Subject: **FIRMWARE UPGRADE—P5.01.02.0**

Model: **APR-24**

**DESCRIPTION**

Figure 2

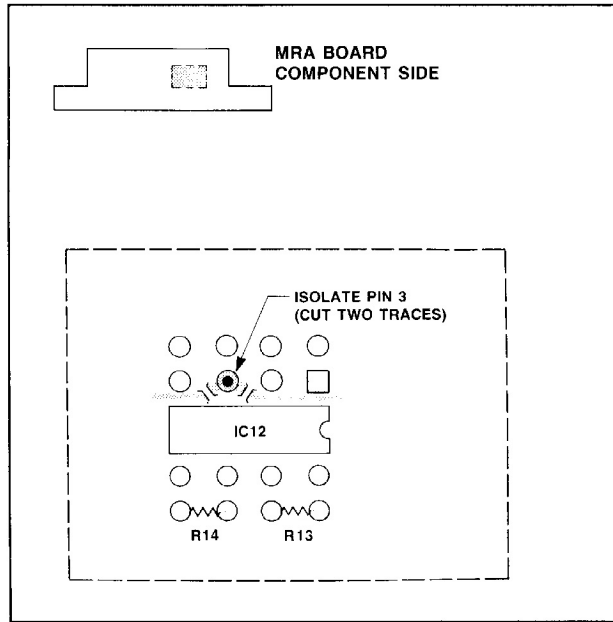
**Component Side (See Figure 2.)**

1. Verify that R13 and R14 are 4.7kΩ. If not, change to proper value.
2. Locate and carefully remove IC12. Save this IC for later replacement. (If damaged during removal, use new IC.)
3. Cut traces going to and from IC12-3 (two cuts).
4. Install 8 pin DIP socket in IC12 location.

Figure 3

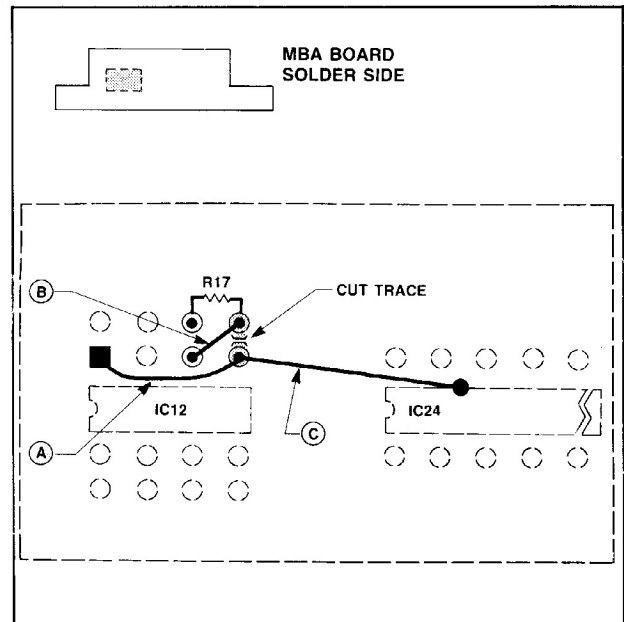
**Solder Side (See Figure 3.)**

5. Cut traces between R17 and IC12-4.
6. Solder jumpers between:
  - Ⓐ IC12-1 . . . IC12-4
  - Ⓑ IC12-3 . . . R17 (at trace cut)
  - Ⓒ IC12-4 . . . feed-thru hole near IC24-2/3
7. Mount IC12 in DIP socket (on component side).

Figure 4

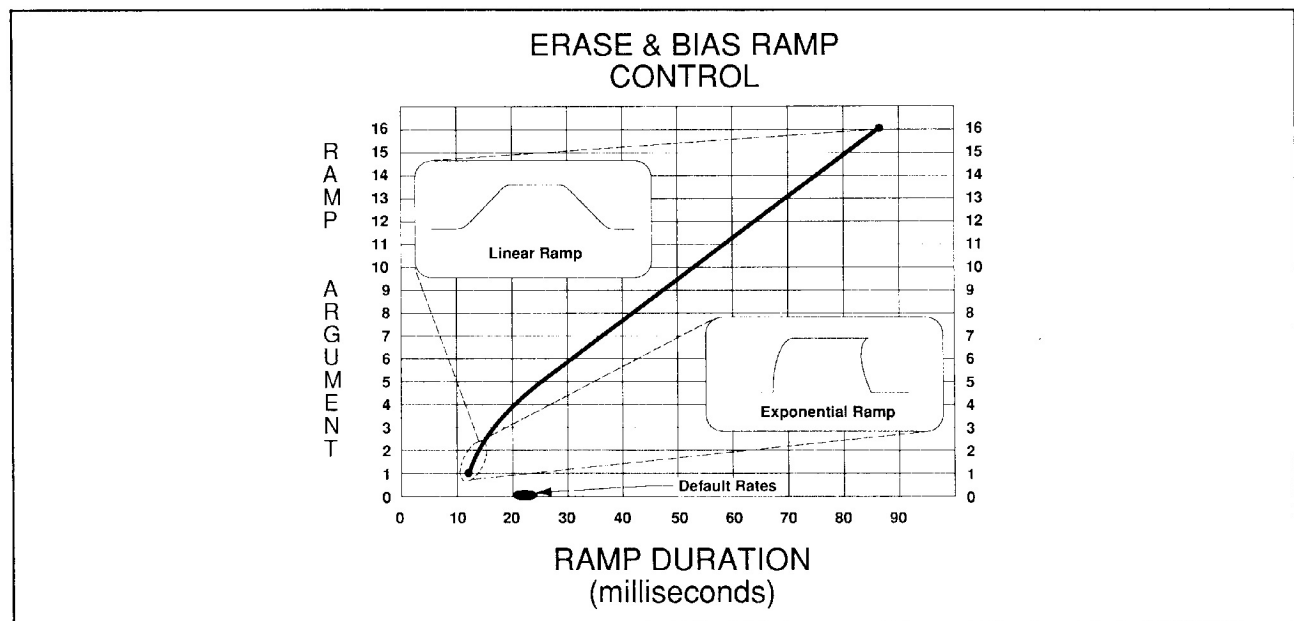
Storage Locations #53 and #54 provide the means to adjust the Erase and Bias Ramp durations respectively. As shown in Figure 4, the storage arguments may be set from 0 to 16. An argument value of 0 returns to machine to its default settings. Changing the tape speed or turning the machine off will automatically return the machine to the default conditions.

While it is permissible to set the erase and bias ramp durations to widely different settings, it is not likely to provide beneficial results, as this can create holes and/or overlaps in the transition.
